Shadrick Creek Restoration Project

Annual Monitoring Report

On January 29, 2021, Equinox received comments on the Draft MY3 Monitoring Report for the Shadrick Creek Stream Restoration Project from DMS. The following are our replies to those comments (in Red).

Shadrick Creek Restoration Site
 Monitoring Year 3
 McDowell County, NC
 NCDMS Contract No.: 00006783
 NCDMS Project No.: 92916
 December 2020
 Sheet 9 of 10

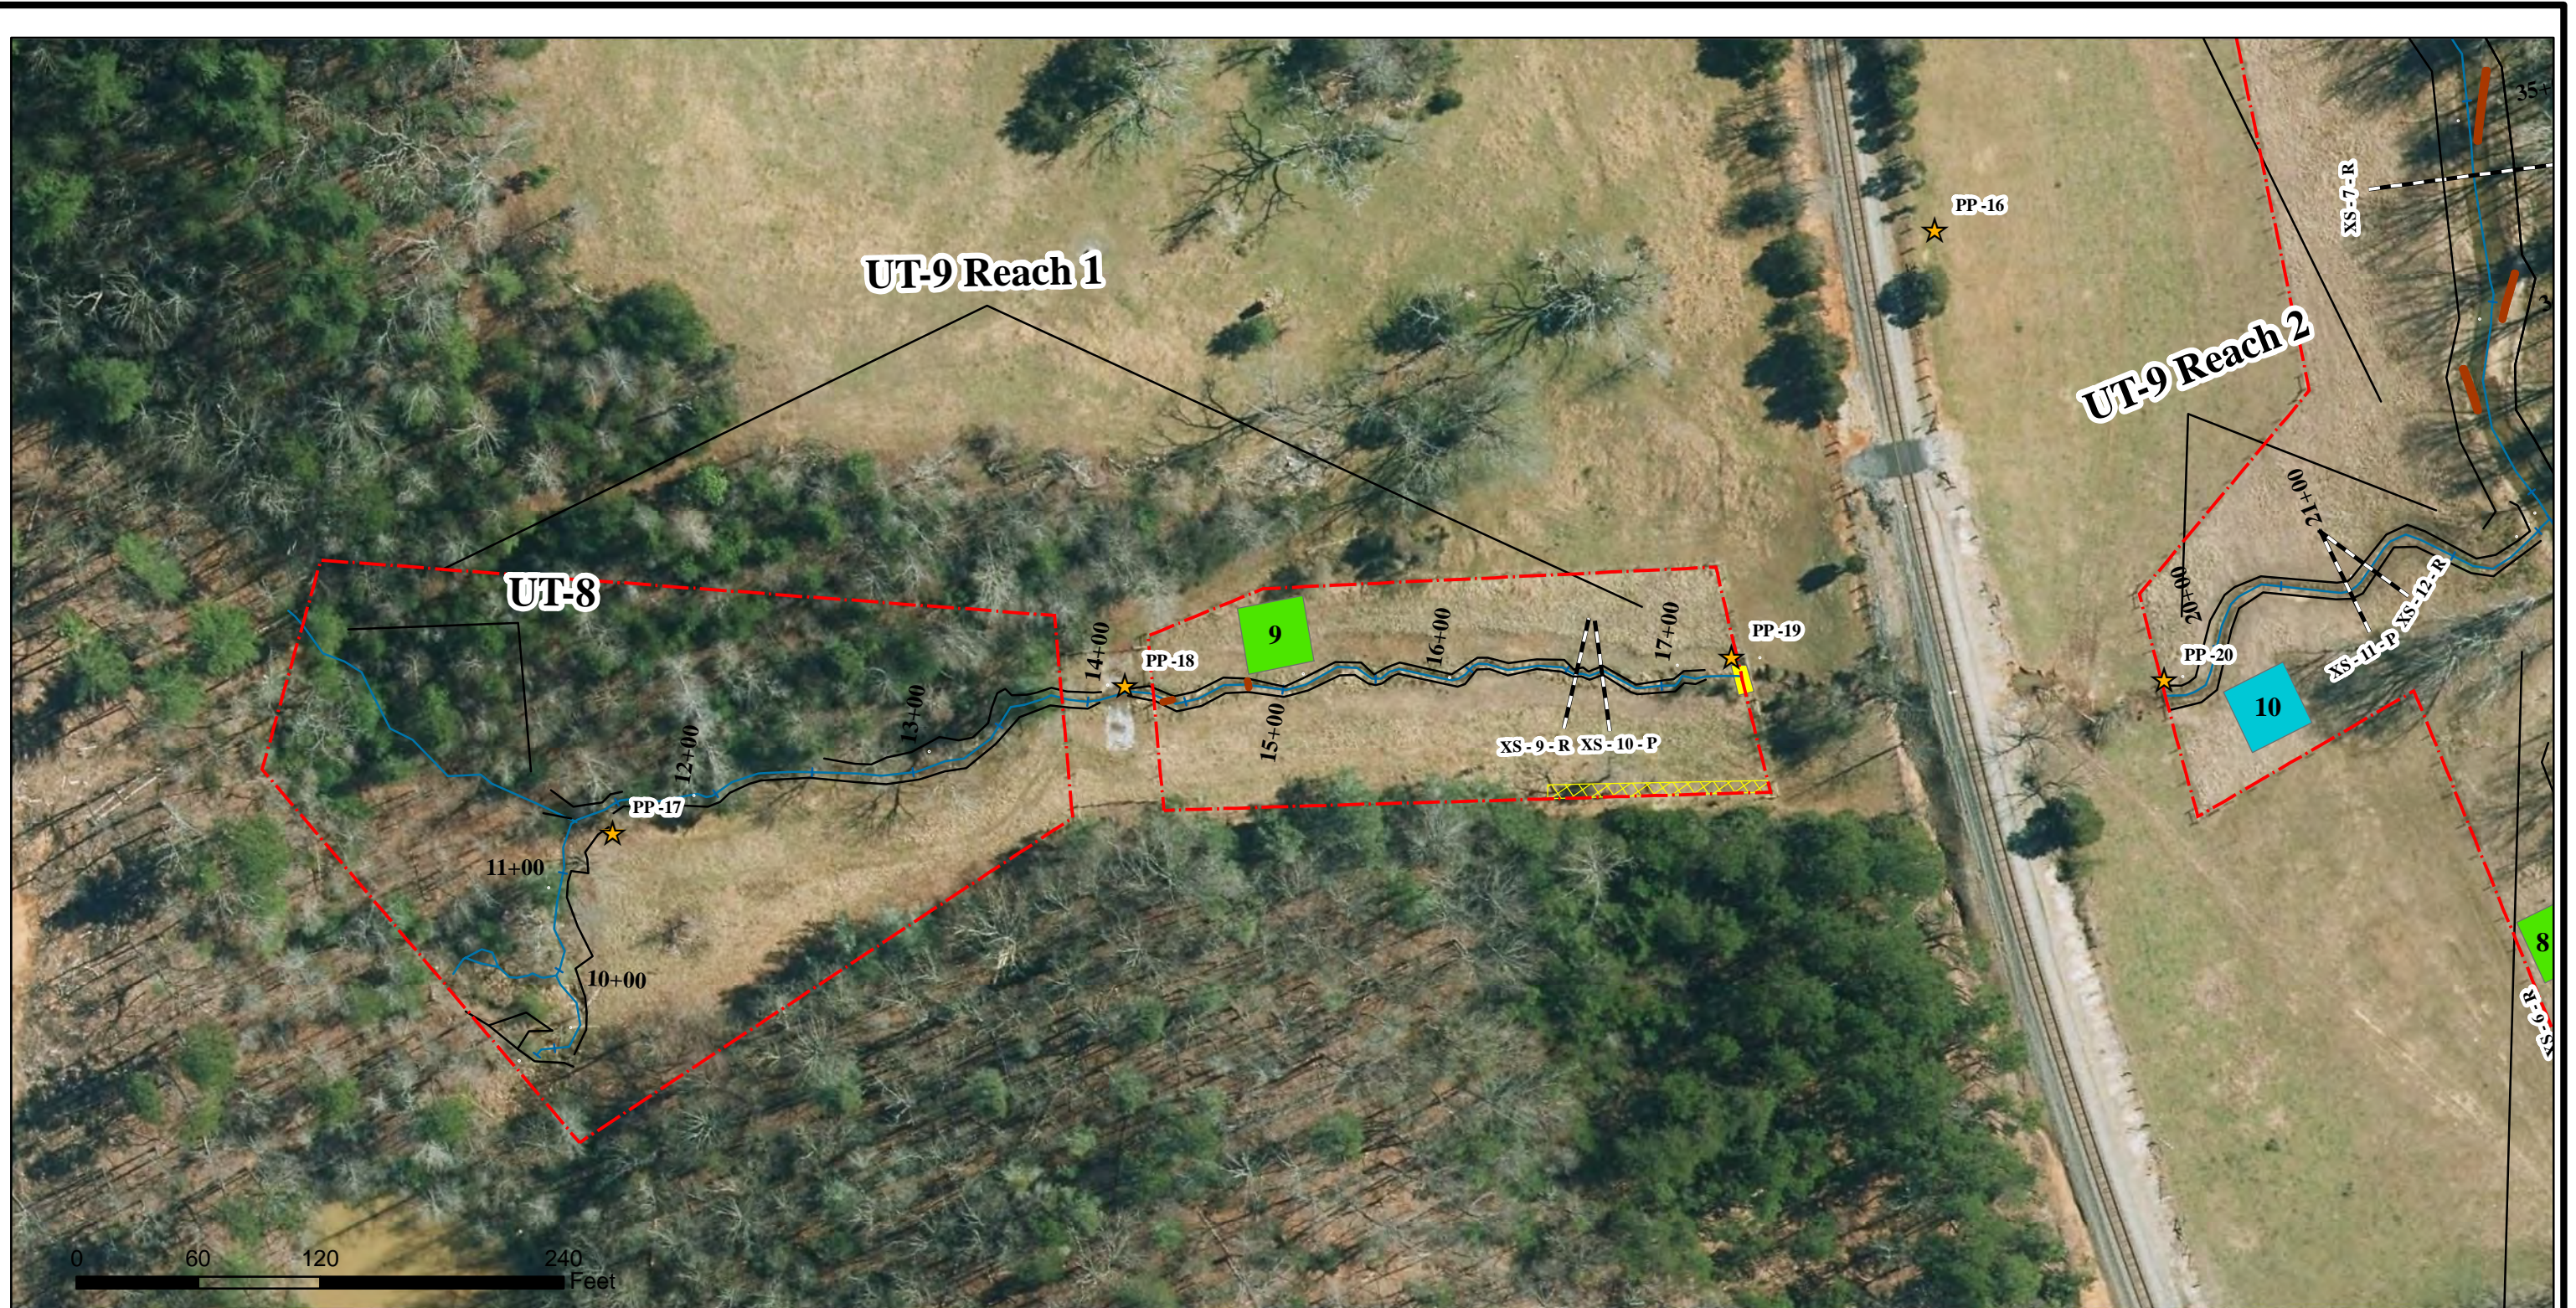
- Please add a short discussion regarding the UT9 cattle encroachment and UT10 headcut and reference photos.
 - For UT9, please note in discussion that cattle encroachment on UT9 was identified in January 2019 and DMS implemented fence repairs in March 2019 to prevent further encroachment. DMS will investigate this new encroachment and employ new measures to ensure cattle no longer enter the easement on UT9. **Text and discussion of encroachment added.**

- Please add location of cattle encroachment on UT9 and UT10 headcut to CCPV. **Cattle encroachment added as polygon and UT10 headcut added as mass wasting stream problem area.**

An initial incident of cattle encroachment on UT9 was identified in January 2019. DMS implemented fence repairs in March 2019 to prevent further encroachment. One area of easement encroachment by cattle was identified during April 2020. The lowest strand of barbed wire was broken along the downstream extent of UT9 Reach 1 above the crossing. This portion of wire was repaired in the field to provide temporary exclusion. DMS will investigate this area of encroachment and employ new measures to ensure cattle are excluded from the easement. No additional areas of encroachment were noted in subsequent site visits in MY3.

Shadrick Creek Restoration Site
 Monitoring Year 3
 McDowell County, NC
 NCDMS Contract No.: 00006783
 NCDMS Project No.: 92916
 December 2020
 Sheet 10 of 10

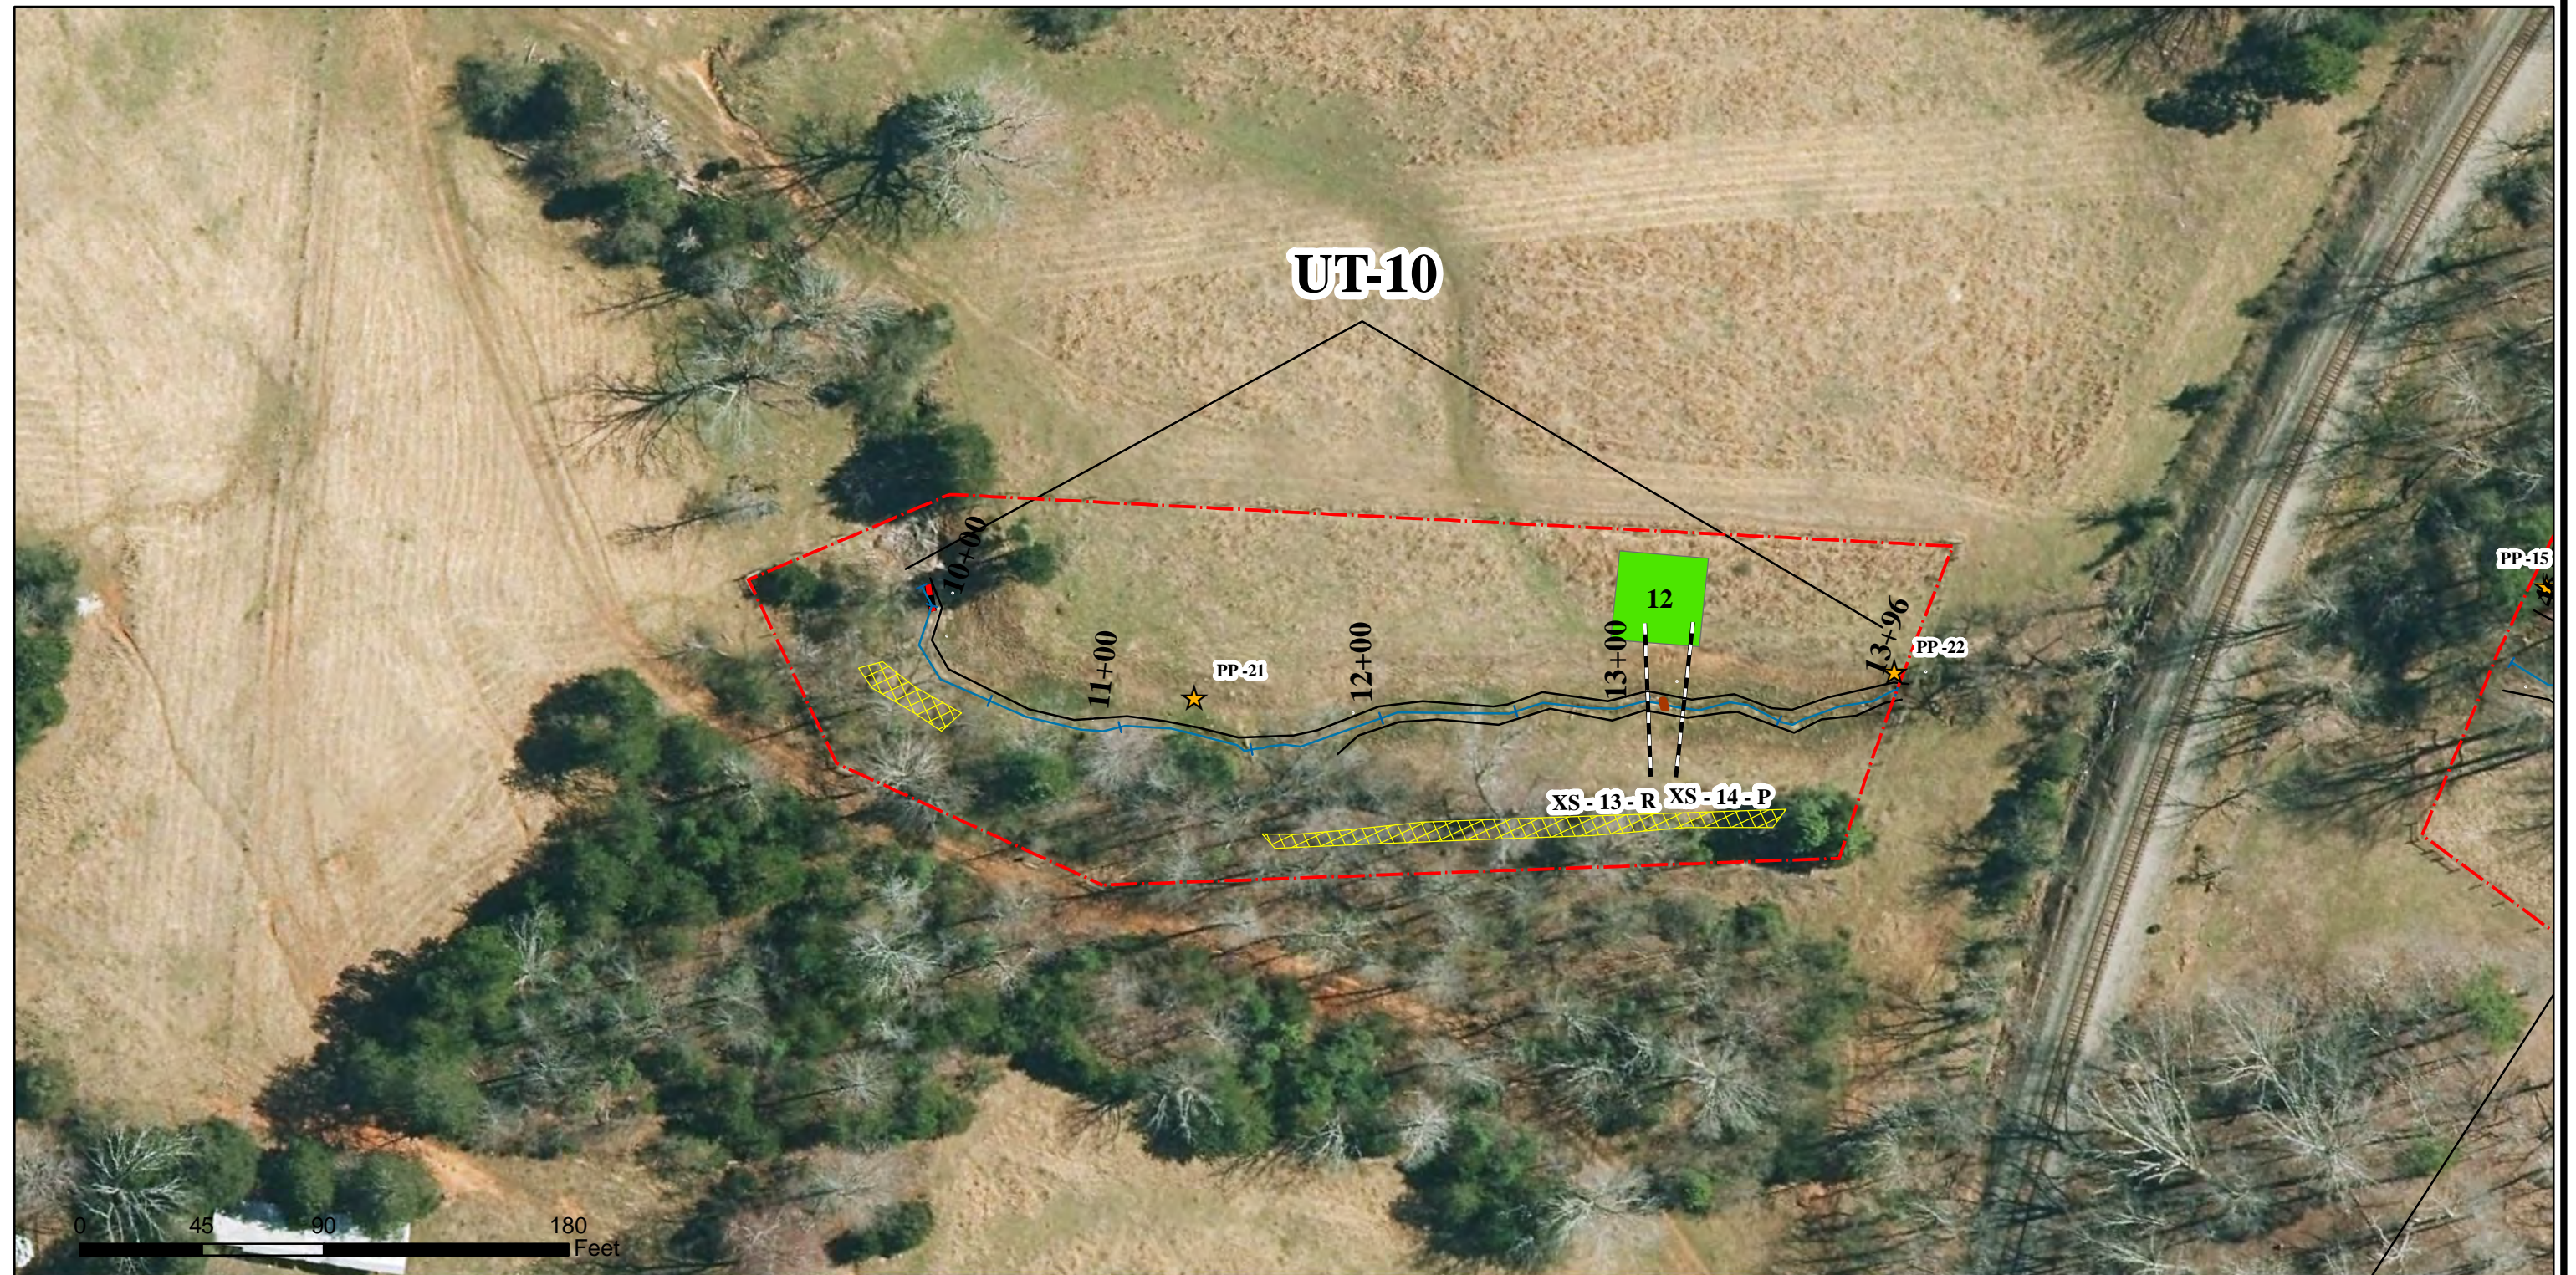
- For UT10, please add discussion that DMS has contracted with an engineer to develop a repair plan for the UT10 headcut. This repair will occur in winter 2021. The repair will be documented in the MY4 report and photos. **Text and discussion of headcut added.**

An approximately 10ft long headcut was documented as mass wasting at the farthest upstream extent of UT10 (Table 5, Figure 2 CPPV). This headcut is migrating towards the easement boundary. DMS has contracted with an engineer to develop a repair plan to be implemented in the Winter of 2021. This repair will be documented in the MY4 report and photos.
